Town of Hilton Head Island
Design Review Board Meeting
Tuesday, December 14, 2021 – 1:15 p.m.
AGENDA

i. Waterfront Restaurant, DRB-002657-2021

ii. Heritage Academy Pavilion, DRB-002658-2021

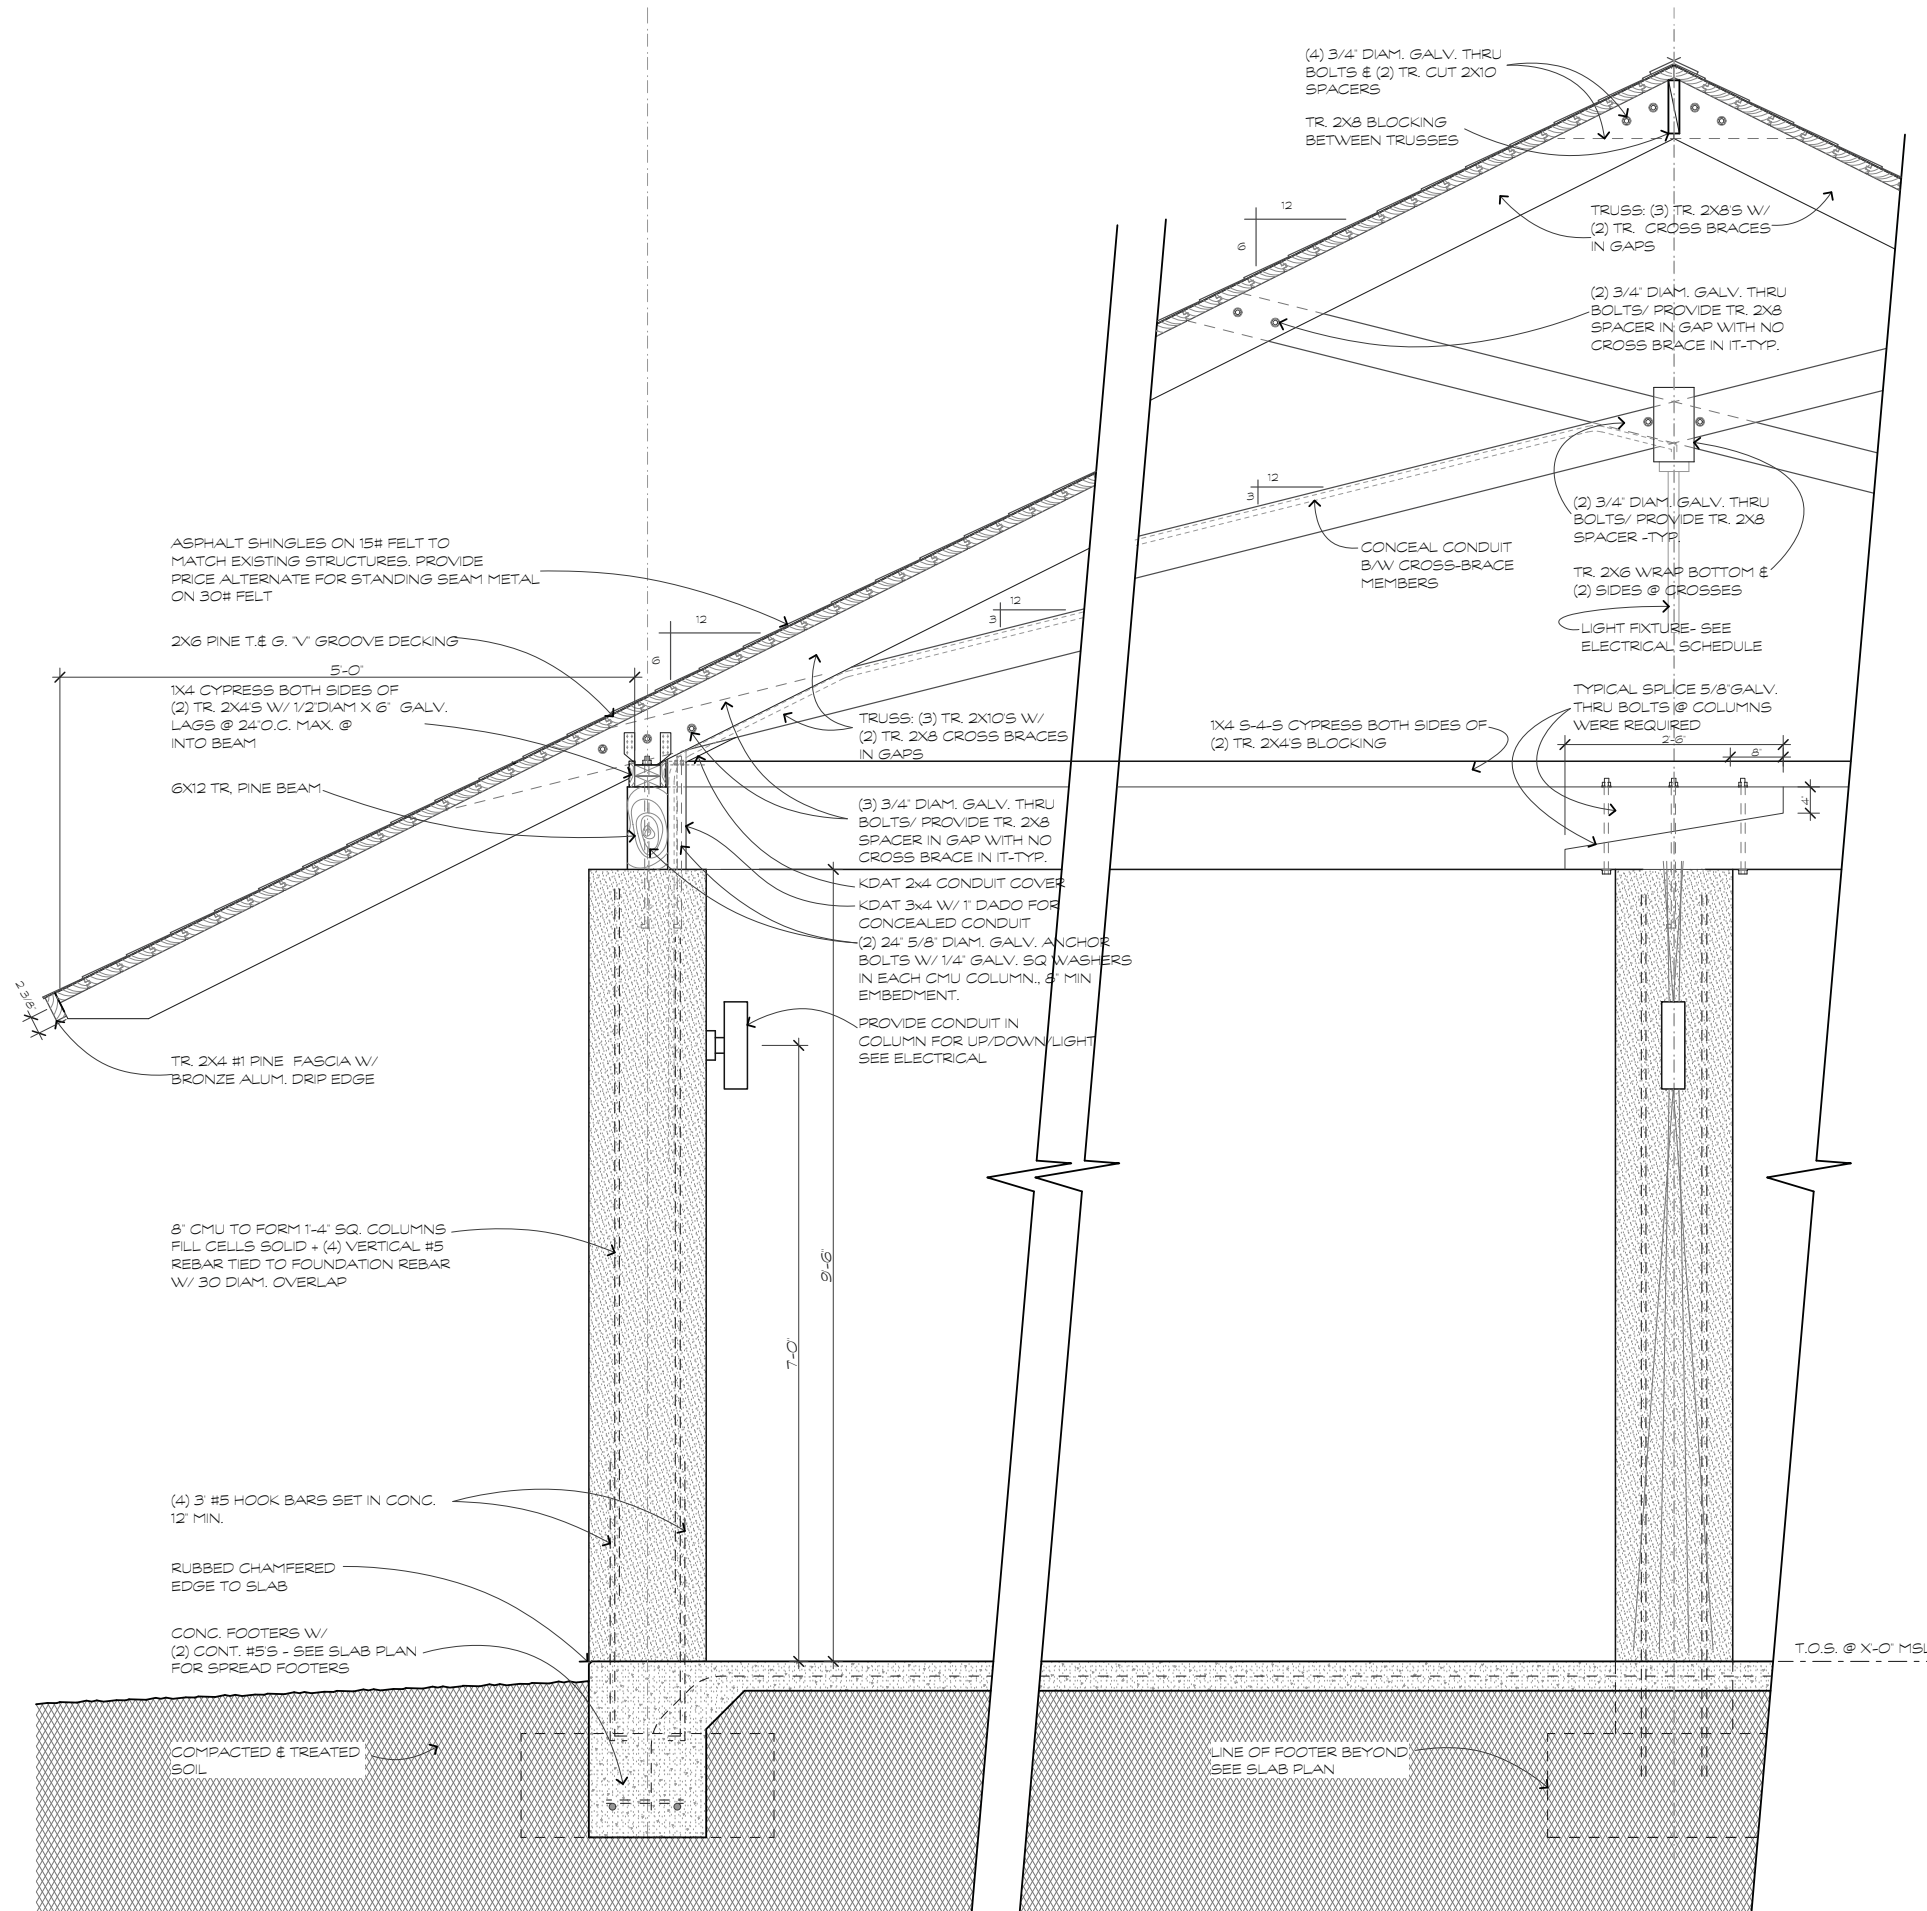
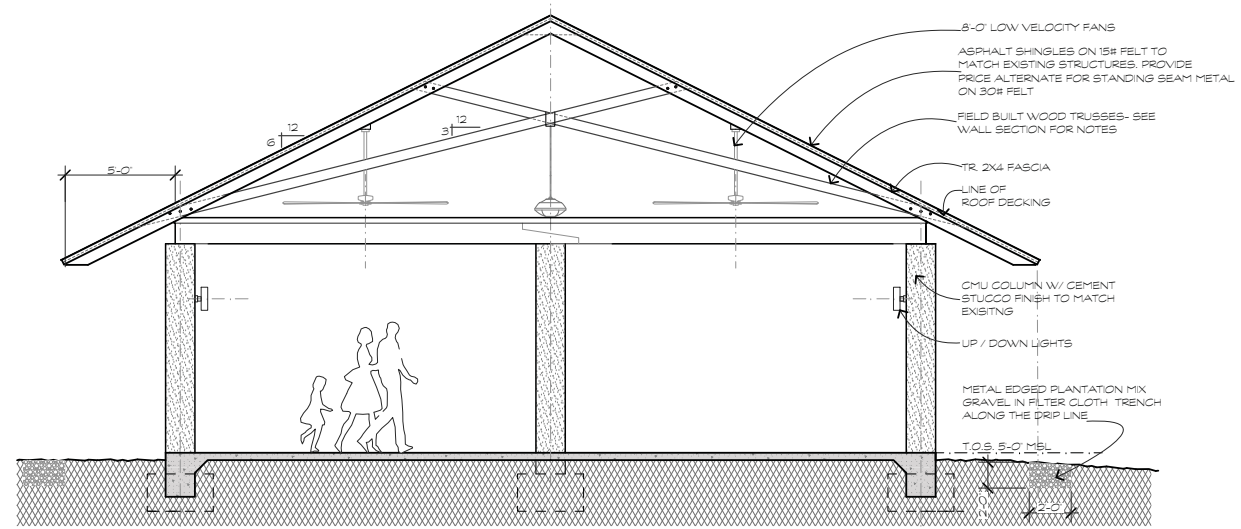
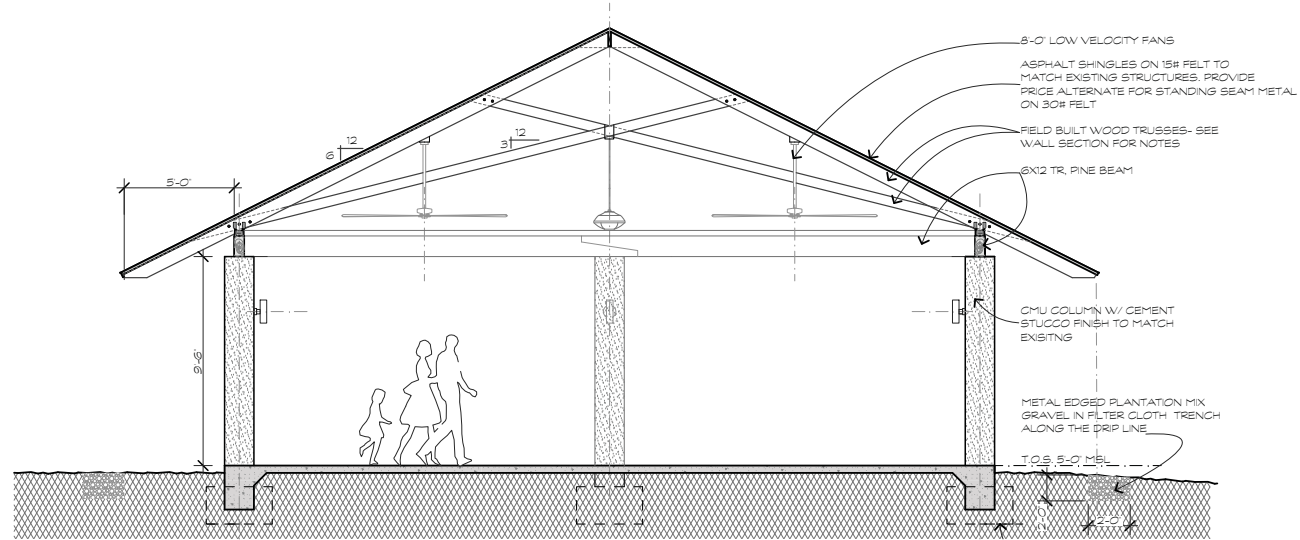
3. Conceal conduits in the pavilion.
 - a. Details have been revised to include trim to cover conduit.
4. Revise the landscape plan to eliminate sod in the street buffer.
